INTRODUCTION

OUTLINE OF NEW FEATURES

The following changes are made for the new model.

11Y6CH001I

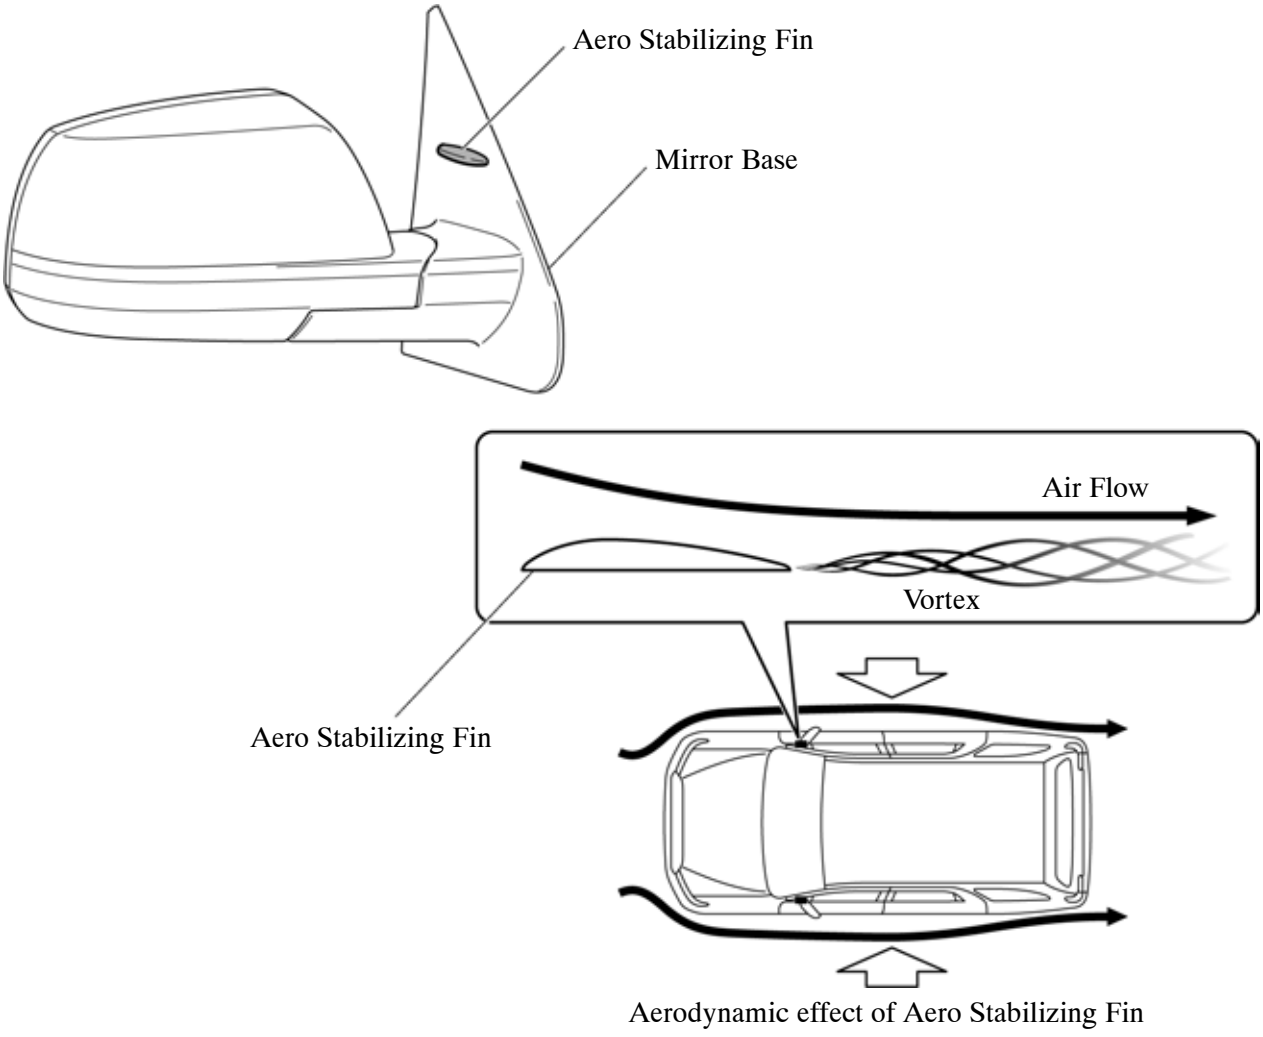
2. Steering Wheel

- A 4-spoke urethane steering wheel, 4-spoke leather steering wheel and a 4-spoke leather and wood steering wheel are provided.
- An audio switch, a telephone switch, and a voice recognition switch are provided for the steering pad switches.
